TITLE: Triple_Axis_Accelerometer-Gyro_Breako

REV:
v12

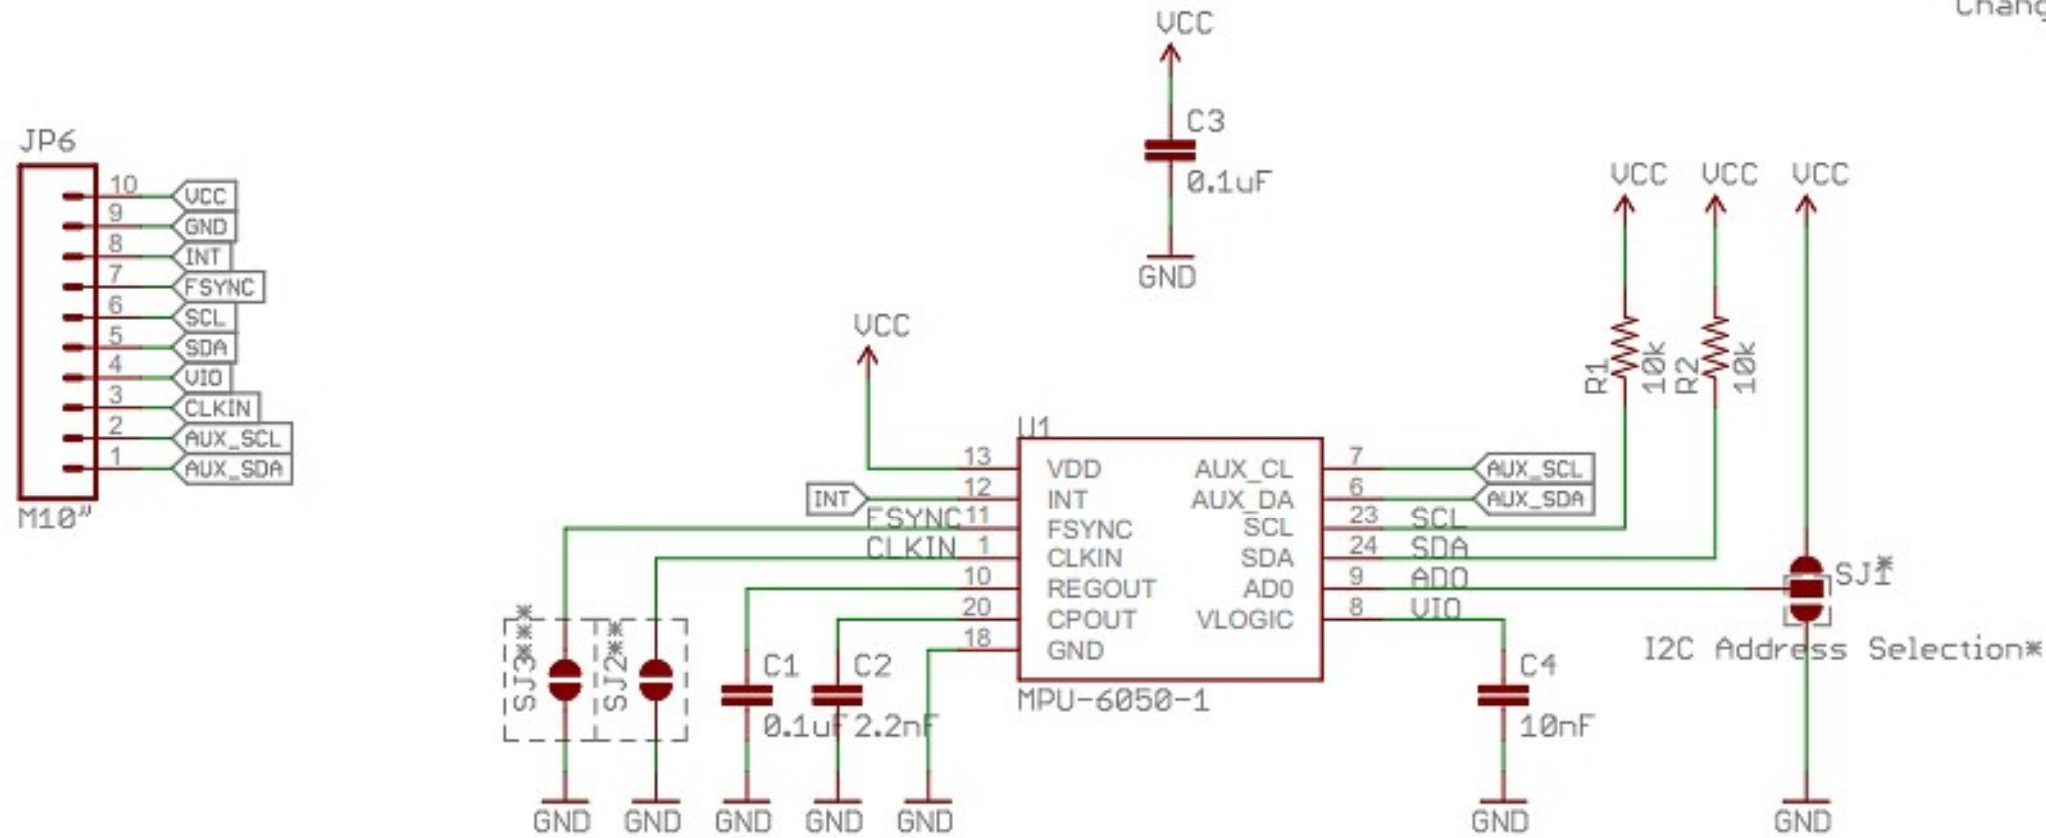
Changes to U11
 SCL and SDA were switched on U10, fixed on U11
 Broke out ULOGIC line
 C2 was mislabeled as 10nF, should have been 2.2nF.
 Added selectable jumpers to CLK, FSYNC and AD0
 Minor layout changes
 Played around with IC footprint.
 Added 4 small tcream squares to middle pad.
 Rounded and elongated pads.

BOM changes
 YES
 C2 is now 2.2nF instead of 10nF

Changes to U12:

* Two MPU-60X0s can be connected to the same I2C bus
 The LSB bit of the 7 bit address is determined by the logic level on pin AD0.
 Default Address = 0x68 (pin AD0 is logic low)
 Alternative Address = 0x69 (pin AD0 is logic high)

** Optional external reference clock input. Connected to GND by default.
 Cut trace for external clock

*** Frame synchronization digital input. Connected to GND by default
 Cut trace for external sync
